Ref: 1244/371/04

Orica Southlands - Modification 1 (MP 06_0919) – Response to Submissions

Orica Southlands - Modification 1 (MP 06_0919) – Response to Submissions

Southlands Industrial Estate 22 February 2013 **Figure D9a**
Final Development Scenario 50% AEP flood level difference map

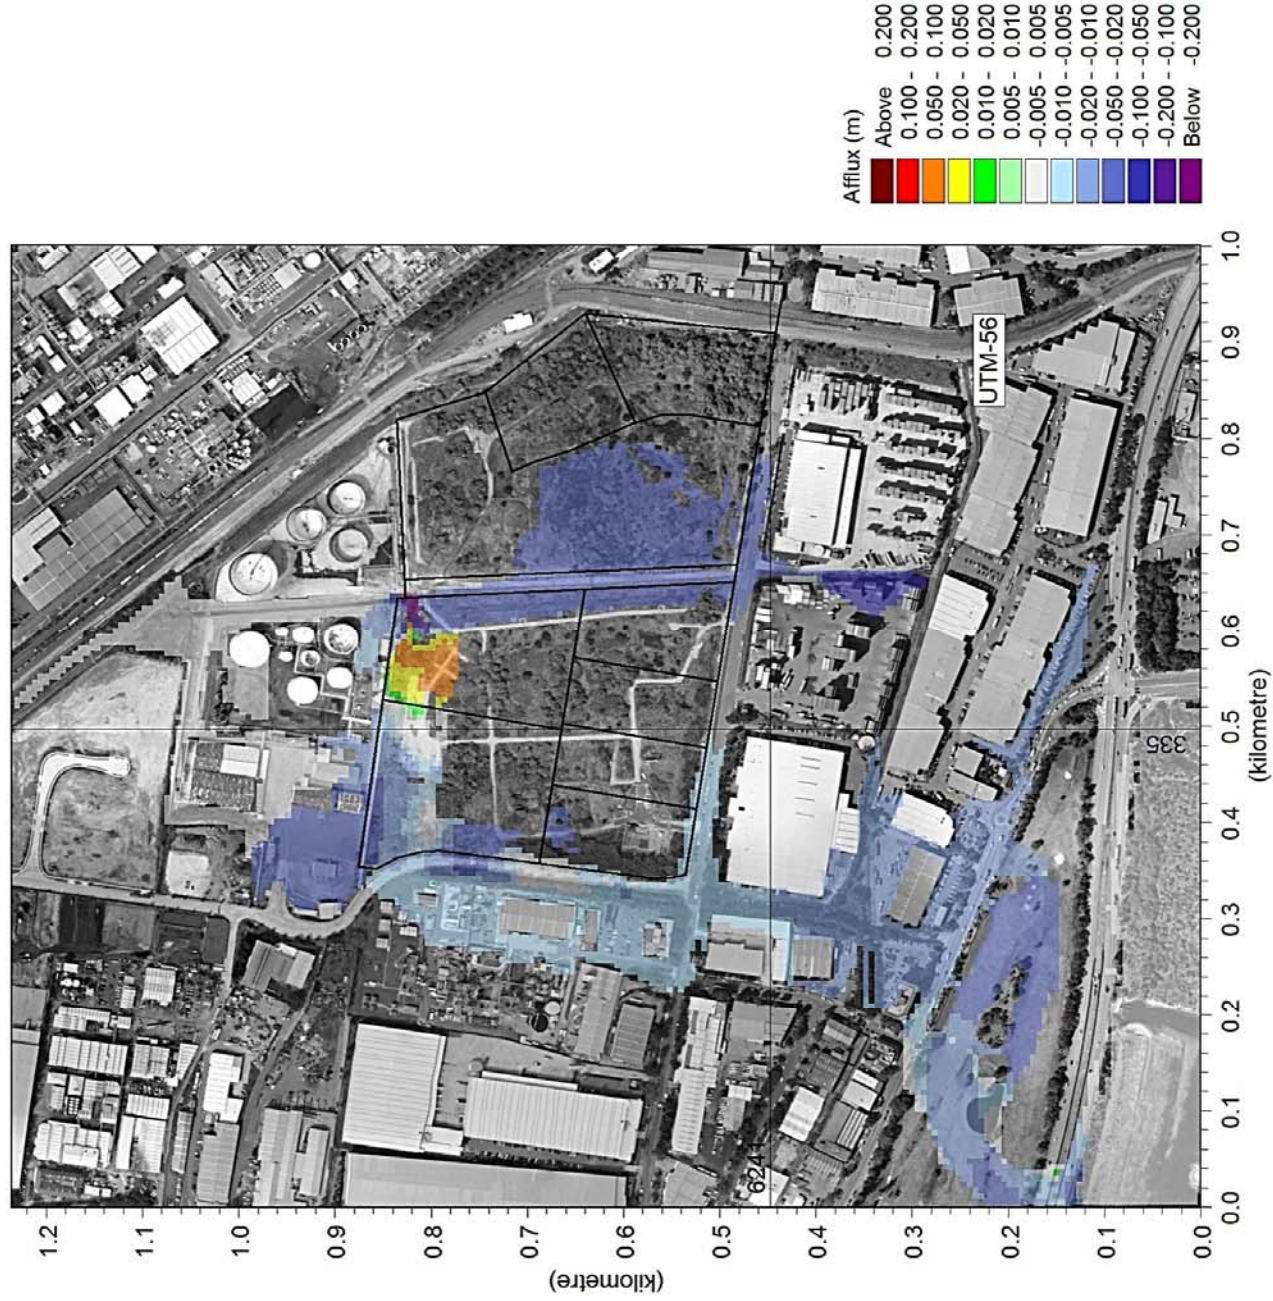
Flood Study	<p>The basis of the Aurecon flood modelling is outlined in the earlier Aurecon Report which forms part of the original Consent documents - <i>Orica Southlands Remediation and Development Project Hydraulic Modelling Report and Response to Exhibition Submissions/Comments – (Report Ref: 204617, 29th November 2010, Revision 3 by Aurecon.</i> This latest advice from Aurecon therefore relies on the earlier report and the flood model parameters established in that report.</p> <p>The only changes to the current modelling are the topography and roughness parameters in the areas where changes to the earthworks design have occurred, with all other parameters remaining the same. The previous report therefore remains relevant in terms of parameters, and the latest Aurecon advice is an addendum to that report.</p> <p>In terms of flood impact we note that the Orica Compensatory Flood basin was never meant to solve the existing flood situation in the area. We are aware that adjoining properties have built below the 1:100 year flood level but the Southlands site cannot solve this situation. Rather the agreed design parameters for the flood storage area agreed with the DoPI was to achieve a situation where the development of the Southland site did not exacerbate existing flooding on adjoining sites (by no more than 10mm - agreed as a measure of accuracy within the modelling). The modified basin configuration continues to meet that requirement.</p> <p>The updated difference plans prepared by Aurecon (attached as Drawings 9a – 11a) (Attachment D) show the difference between the proposed flood levels at the various</p>

<p>storm events compared to the existing. This clearly shows that the modified basin continues to meet the agreed parameters of no additional flood impact on adjoining lands.</p> <p>Aurecon do advise that there is a difference on adjoining land between the modification and the approved plans that benefit some properties and increase flood levels on others by up to 20mm in the 1:100 year event (see Attachment H which shows the change in levels compared to the approved drawings for the 1% event). However, all sites continue to have no greater flood impact than the existing case – ie current flood conditions, as shown in Attachment D.</p> <p>The area now proposed as Lots 7, 8 and 12 are generally shown in an area that is already above RL4.2 (which is the maximum 1 in 100 year flood level across the Southlands site) and not subject to 1:100 flooding currently. Accordingly the flood difference mapping will correctly show no change to afflux levels in this area.</p> <p>We understand that the DoPI is referring the revised flood modelling to the independent reviewer as was the case with the Project Approval.</p>

SOUTHLANDS FLOODPLAIN MANAGEMENT STRUCTURES
SCALE: 1:500

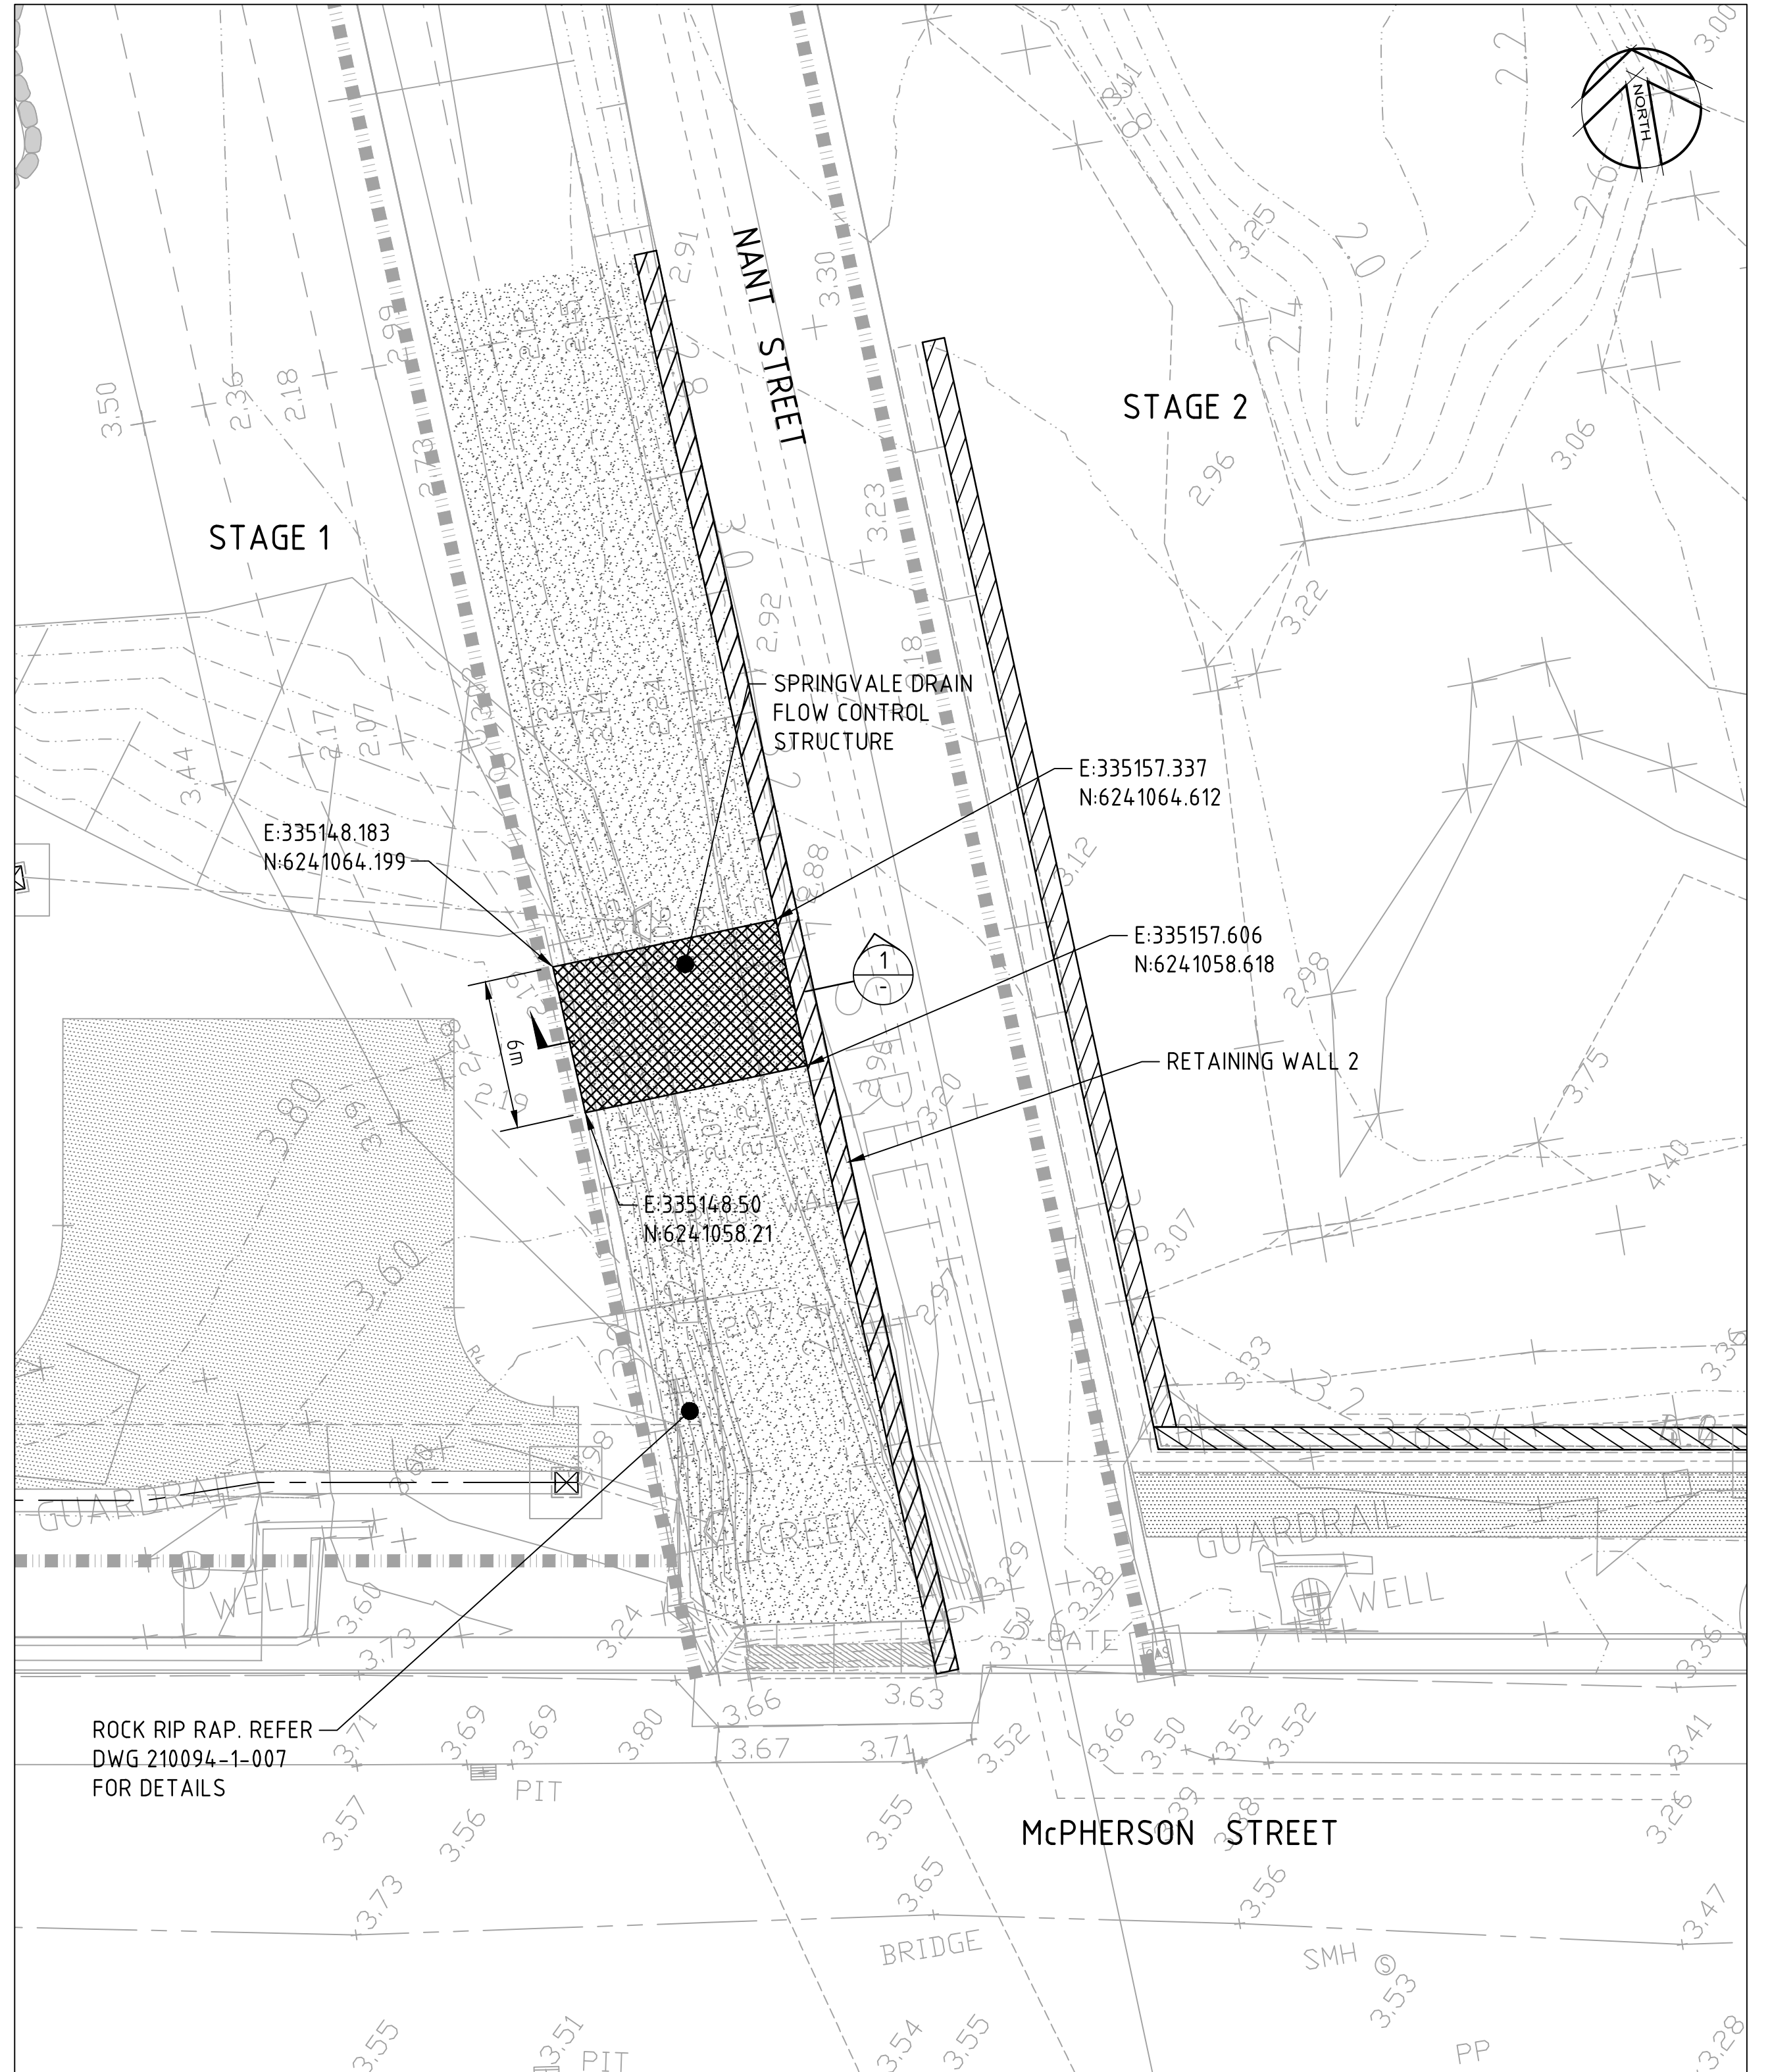
<p>best practice.</p> <p>The McPherson Street culverts create an existing control and there is has never been any proposal by Orica to amend these culverts.</p> <p>Plans showing the control point (the constriction) are included at Attachment G and have been issued to Botany Bay City Council for review.</p>
Provide positive covenant on title	<p>Orica will be creating an easement on the title of the sale lots noting that the area is part of the compensatory flood storage area and is not to be filled.</p>
More detail Condition 13, Schedule 3	<p>Orica is not seeking variation to this Consent Condition. We do however note that as long as earthworks levels are not varied within the nominated flood storage area there will be no impact to the flood levels. Any change in level on the building pads will not impact on flood levels as they do not contribute to storage.</p> <p>Any works post construction, as long as they maintain levels in the basin area will therefore maintain storage. All finished levels will be reviewed and subject to certifier review prior to the issuance of an occupation certificate, so we do not see that the Condition requires any change as it simply identifies the issue for the Certifier.</p> <p>Orica suggests DoPI consider the need for any changes to this condition.</p>

<p>Flood storage basin</p>	<p>The “weir” outlet approved in the current consent was defined by the accompanying Aurecon flood report (Aurecon Flood Modelling Report – Orica Southlands Remediation and Development Project Hydraulic Modelling Report and Response to Exhibition Submissions / Comments – (Report Ref: 204617, 29th November 2010, Revision 3 by Aurecon) as follows:</p> <p><i>All variables have been maintained other than the introduction of a level control structure approximately 25m upstream of McPherson Street on Springvale Drain. The weir is effectively a constriction to reduce the channel width to 3m between the bed and an elevation of 3.2m AHD (approximate bank level by the construction of wing walls that extend into the bank). This allows low flows to be maintained with relatively little impact while larger flows are diverted into the detention basin through raising the water level.</i></p> <p>The latest flood modeling maintains the restriction in Springvale Drain at a location approximately 25 metres upstream of McPherson Street. This area is to be reinforced with a reno mattress structure as shown on drawings included at Attachment G.</p> <p>The restriction will also be armoured with additional rock riprap armouring to improve stability around the restriction. The rock armouring (350mm thick using D50=200mm rock on Bidim A44) was calculated based on the estimated 100 year flow velocity. This in turn means that the potential for scour is also relatively low, when compared to a swiftly flowing stream. Our engineers (Cardno) advise that this is best practice.</p> <p>The McPherson Street culverts create an existing control and there is has never been any proposal by Orica to amend these culverts.</p> <p>Plans showing the control point (the constriction) are included at Attachment G and have been issued to Botany Bay City Council for review.</p> <p>We have also forwarded requested plans of the Water Surface Levels for the 2 year, 10 year and 100 year ARI events to Council and copied them to the DoPI. Similarly we have forwarded the requested sections of the northern channel directly to Council and copied them to the DoPI.</p>
